A CAUTIONARY TALE: DESIGN MUST BE BASED IN YOUR PHARMACY REALITY!

Our third Design Challenge submission comes from a Toronto-area pharmacist who would like to remain anonymous. He is currently working in a chain pharmacy but plans to open a new medical clinic dispensary. As often happens, the firm designing the building has offered to design his pharmacy as well. The only problem? **They don't know the business of pharmacy!**

HERE'S THE SUGGESTED LAYOUT

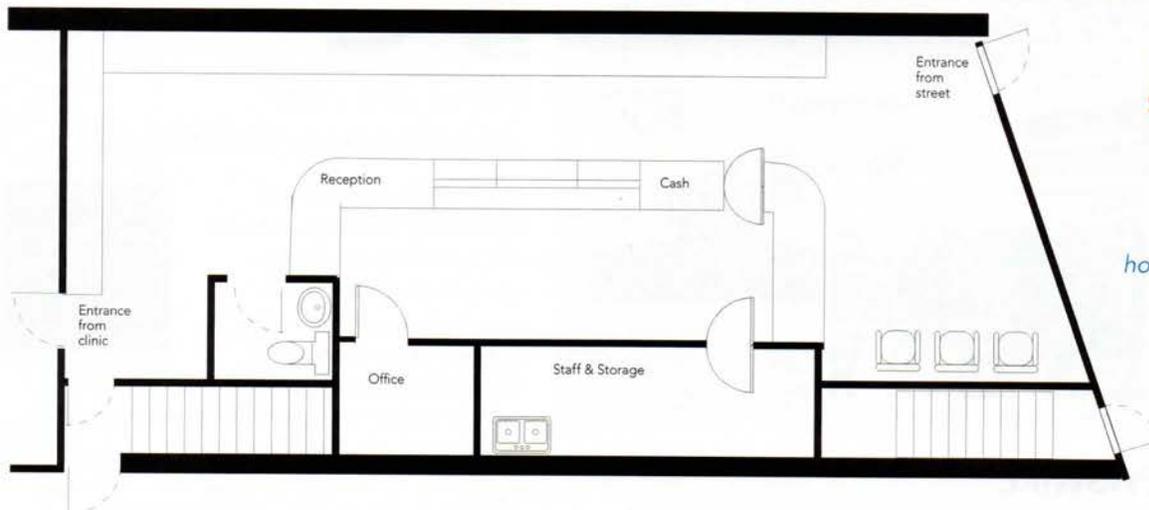
- 1 There is only **one exit** from the dispensary into the front shop. This means any staff at the reception/office end of the dispensary must walk all the way to the opposite end (more than 18 feet) to exit to the front shop.

- 2 Not only is there no designated semi-private counselling area, there is **no private counselling room**—making this pharmacy illegal in Ontario (and in most other provinces).

- 3 Speaking of legalities, there is **no sink** in the dispensary. There is one shown in the storage area, but that won't cut it.
- 4 The main **dispensary counter is shown 15" deep**. Usually dispensing counters are 24"–30" deep.

- 5 The **pharmacy is backwards**. As we discussed in our previous article, the reception should be in a natural path from the entrance. In this case, we have 2 entrances at either end of the space: One from the medical clinic and another from the street. The usual way of handling this design dilemma is to find out what percentage of clients will be approaching from each entrance. In this case, the owner has indicated the majority of patients will enter from the street; therefore, the reception needs to be relocated closer to the street entrance.

- 6 The **service counters** (Rx in and Rx out/cash) are both **too wide**, allowing too many clients to approach the counter at the same time.
- 7 The problems are not only in the dispensary: The **frontshop shelving is shown 27" deep!** In a standard retail pharmacy the front shop would use 14" or 16" base shelves (with

smaller shelves above). In medical clinic pharmacies, with their emphasis on prescription filling, frontshop shelving should not be more than 12-14" base shelves. This also applies to the shelving in front of the Rx counter, shown as 14" base shelves. These should be narrower, which will also allow the needed increase in the depth of the main dispensing counter.
